901 Harrison

Design Review Board

MACFARLANE PARTNERS & ANKROM MOISAN ARCHITECTS, INC.
DPD #3016723 / **NOVEMBER 05, 2014**

EMBRACING THE LANDMARK FACADE

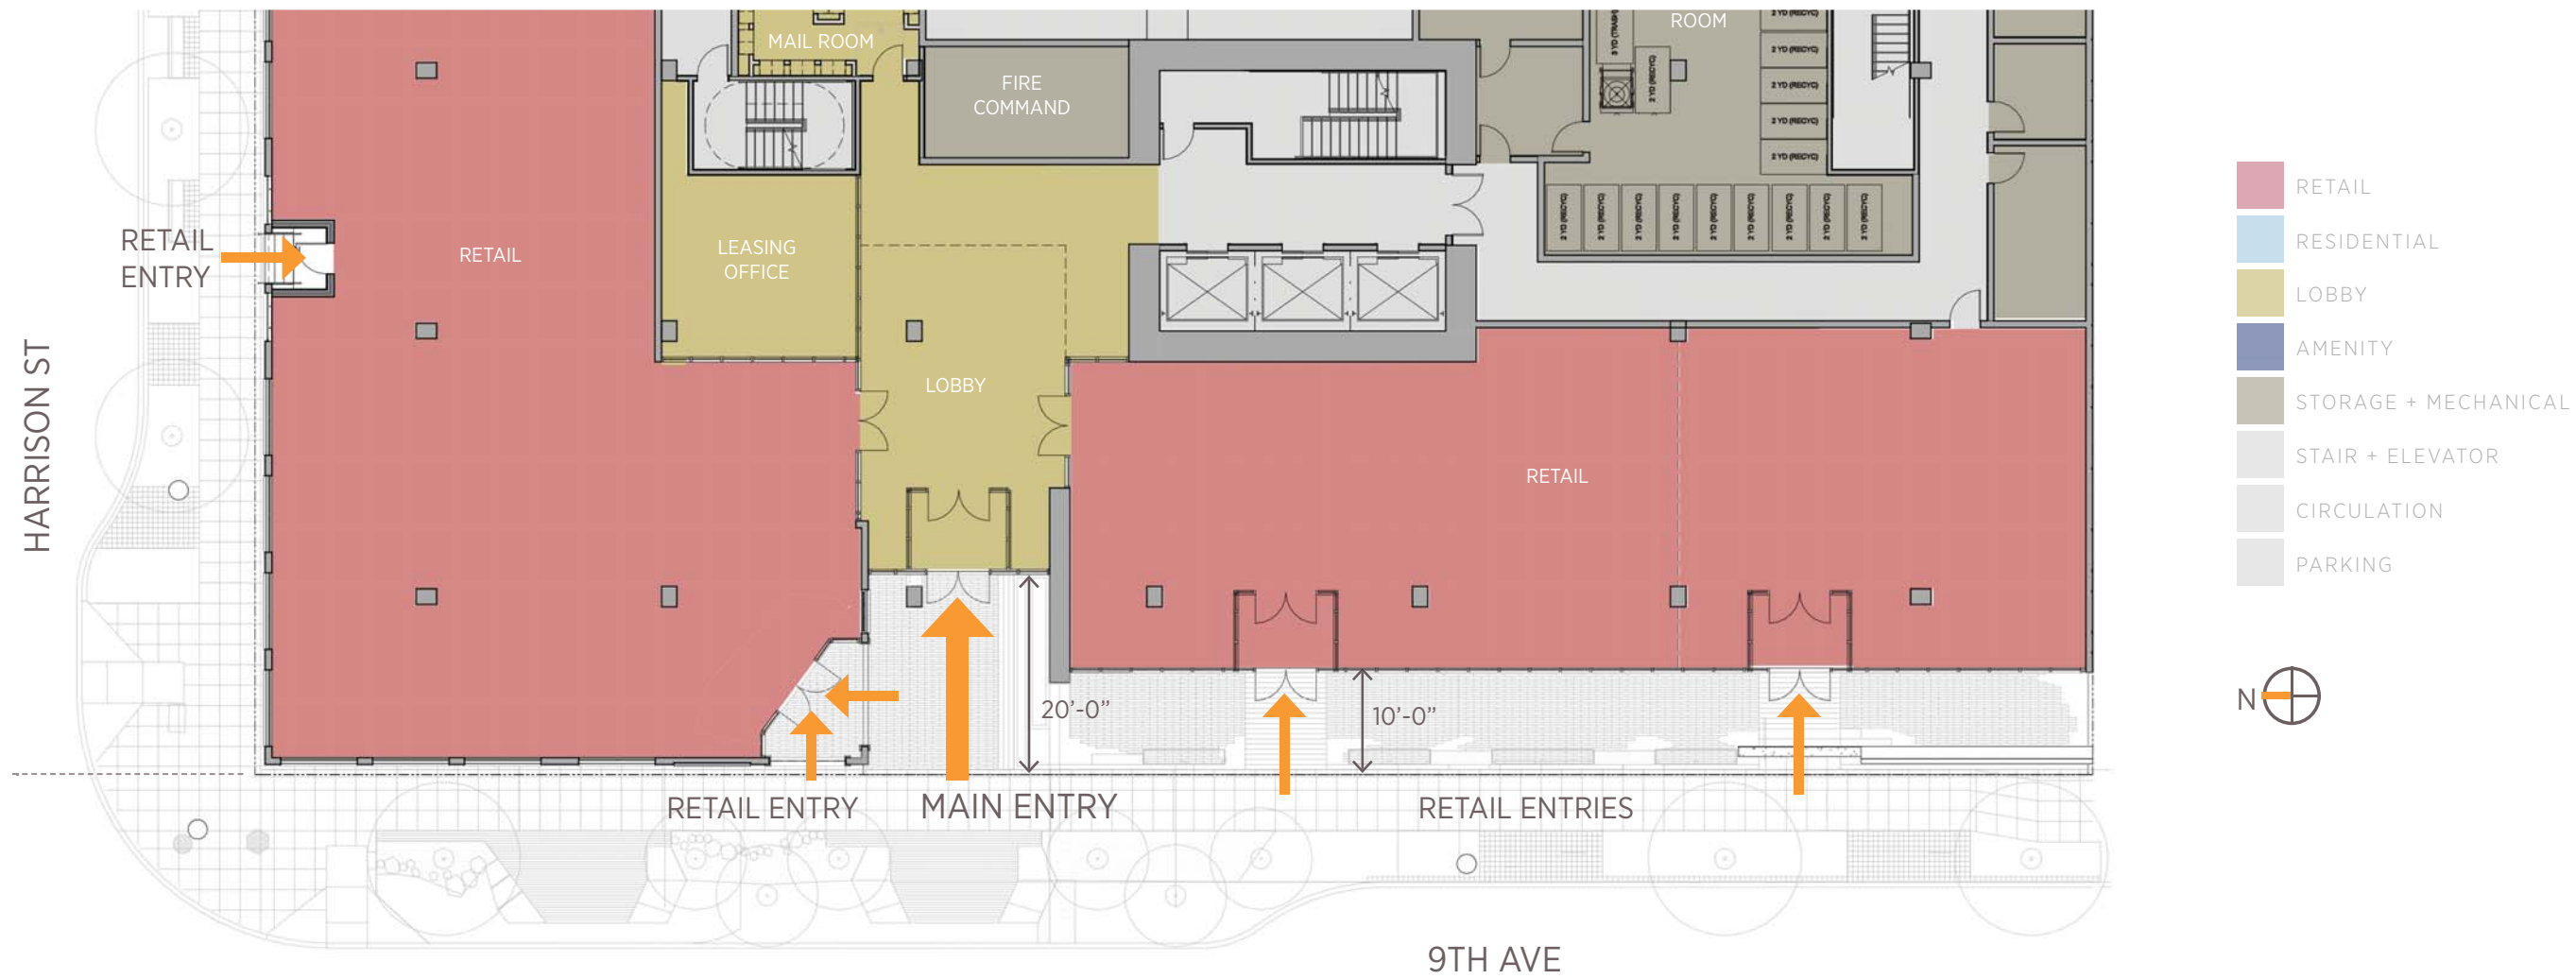
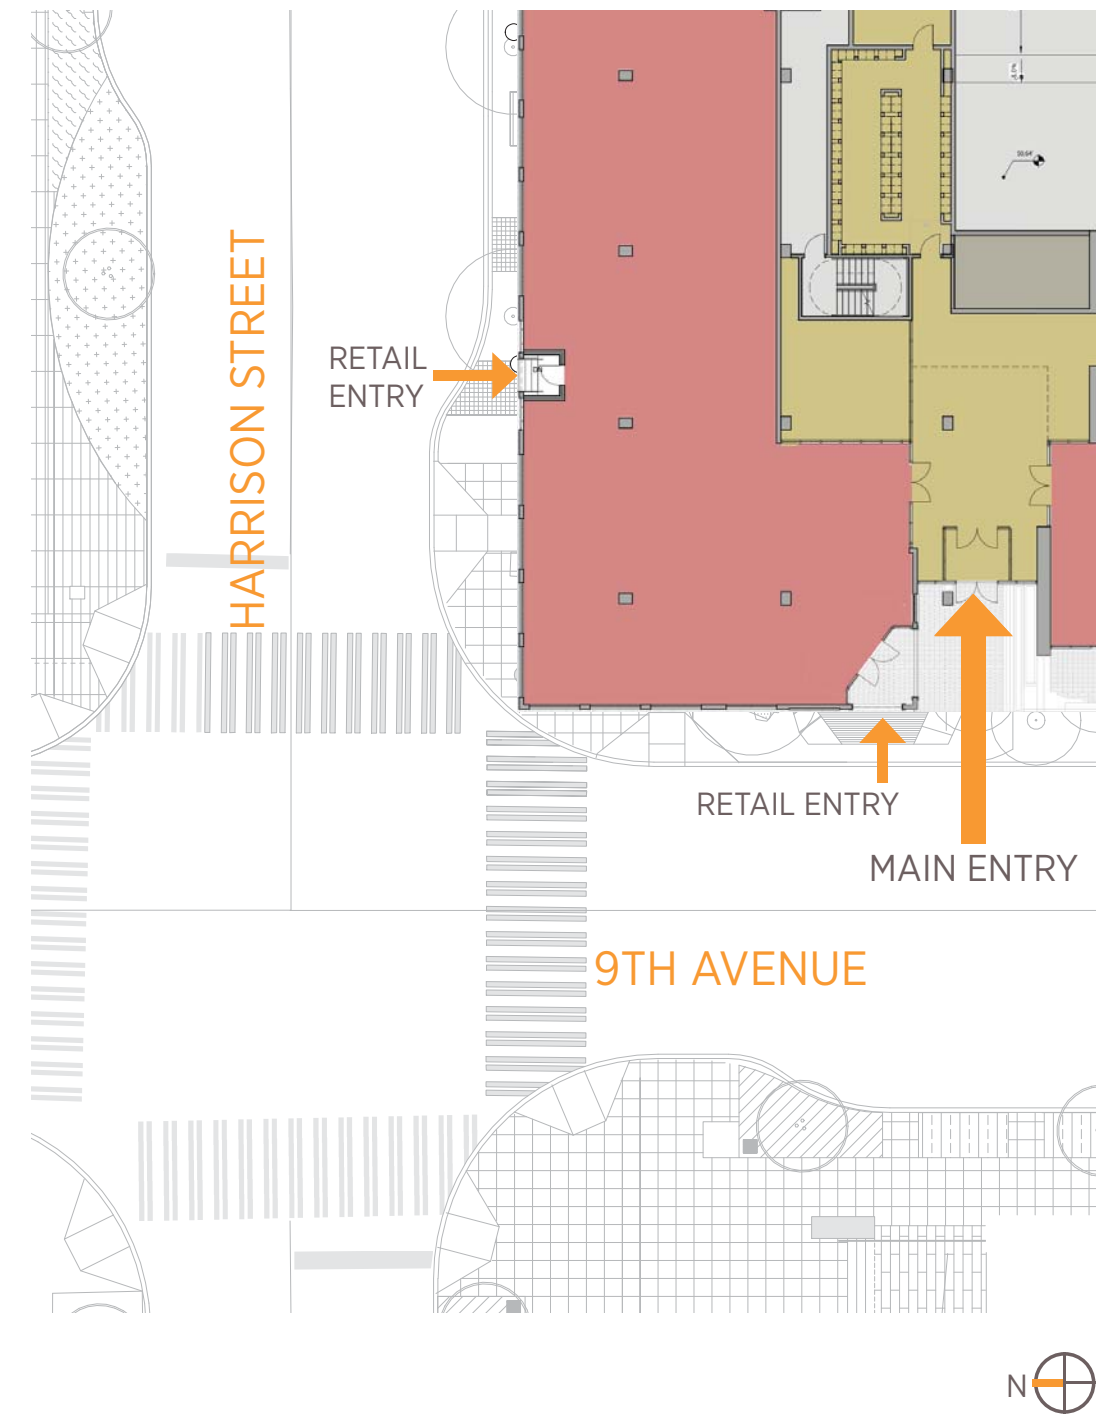
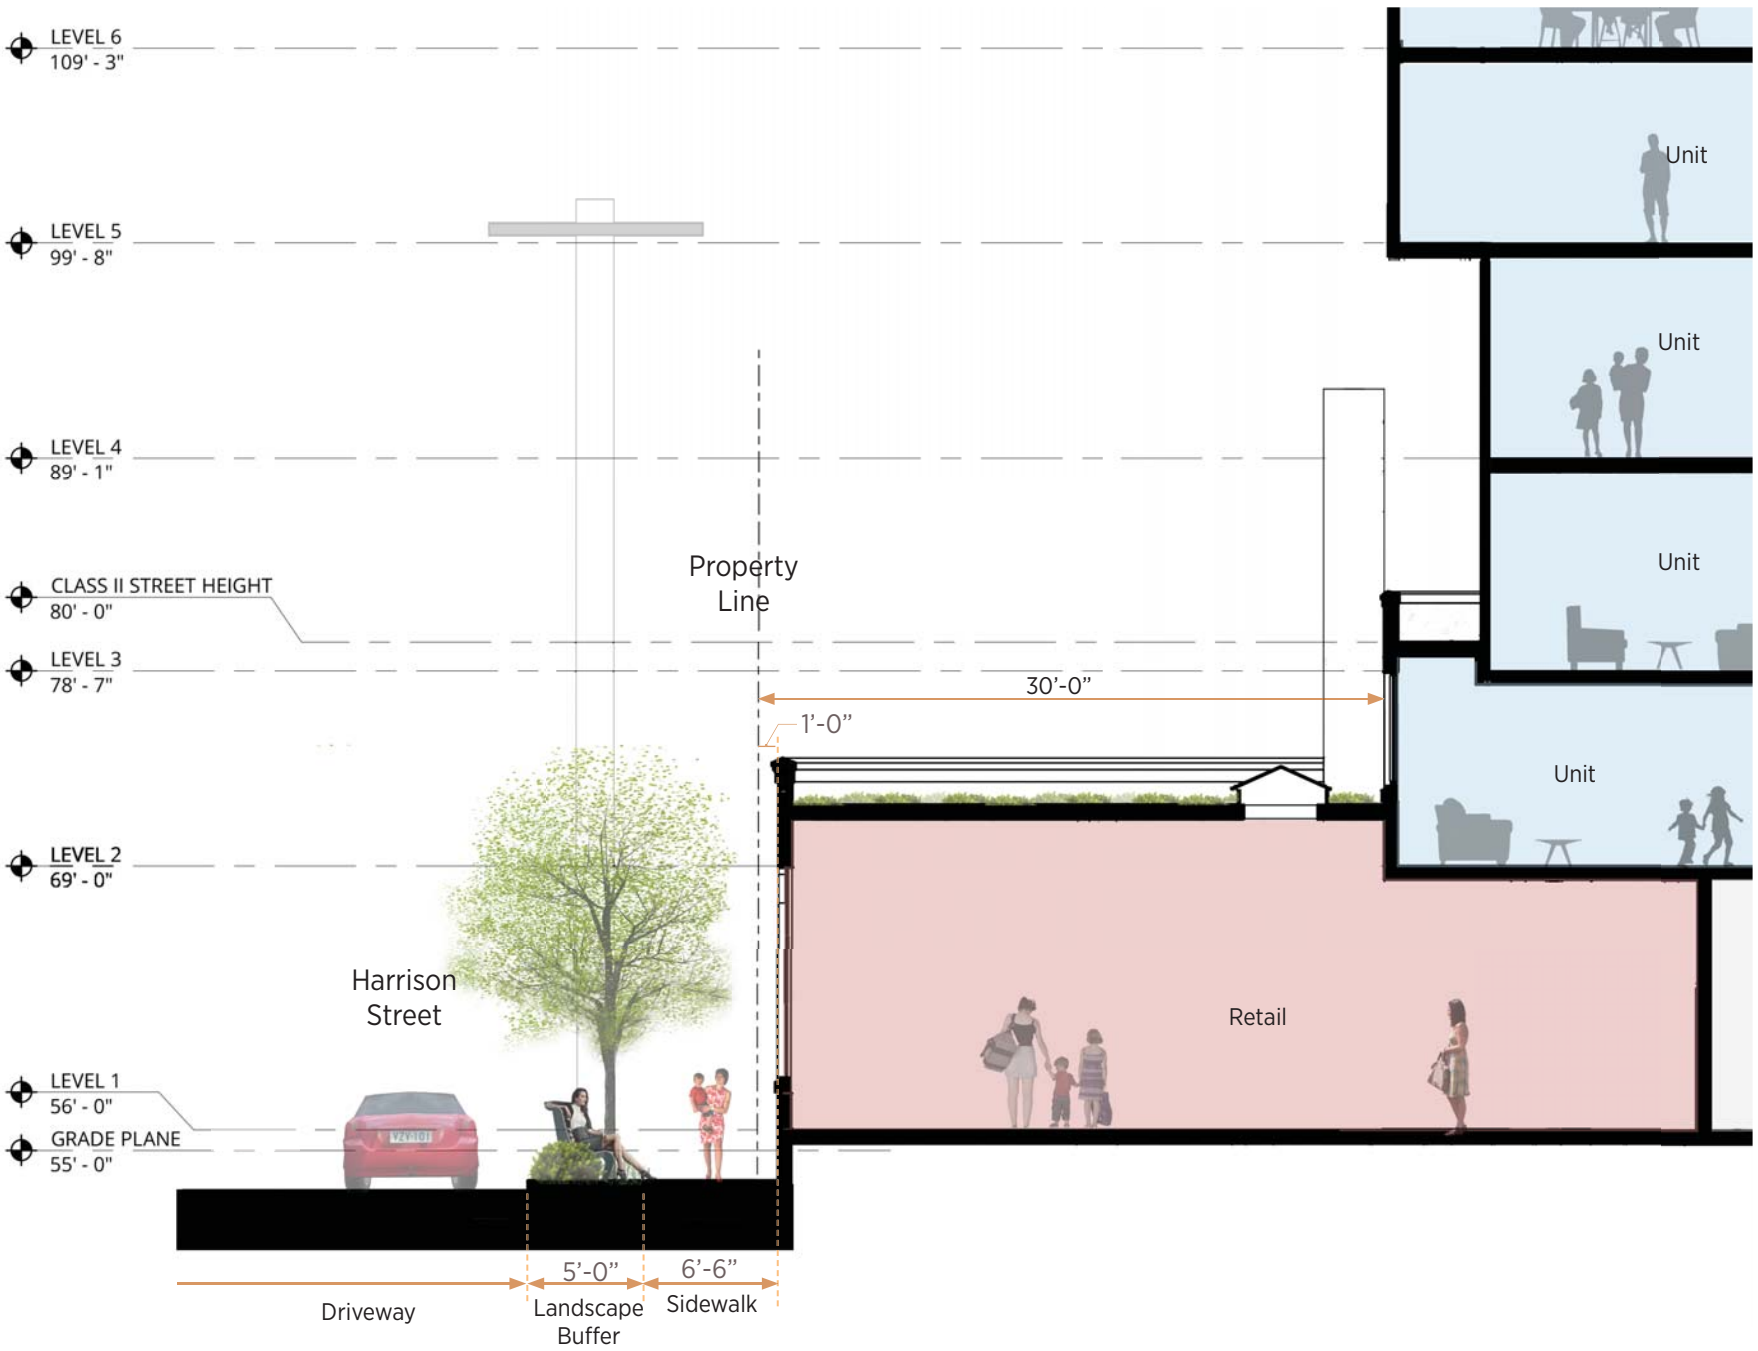
- 1a “...slender tower relates better to the context ...” (CS1.B.3, CS2.II.ii)
- 1b “.The tower should be further modulated on the north and west facades to enhance the articulation and the slender appearance of the tower...” (CS2.A.2, CS2.II.ii, DC2.A)
- 1c “The design of the podium and tower design should be integrated...respond to the context...” (DC2.B, DC2.D)
- 1d “...should consider the possibility of incorporating the existing building façade into the proposed development....” (CS3.B.2, CS3.II.ii & iv)

We propose a 3 ft ‘pushback’ on the new facade all the way around the Landmark facade. It creates a building form that embraces and intergrates with the Landmark facade.

The roof line of the new precast facade at podium will be an extension and continuation to the existing stepping roof line of the Landmark facade.

Rebuild upper facade & clerestory with original character of the historic building

Retain historic facade and windows

3' setback from historic facade

18' setback from historic facade

10' setback to accommodate required powerline setback
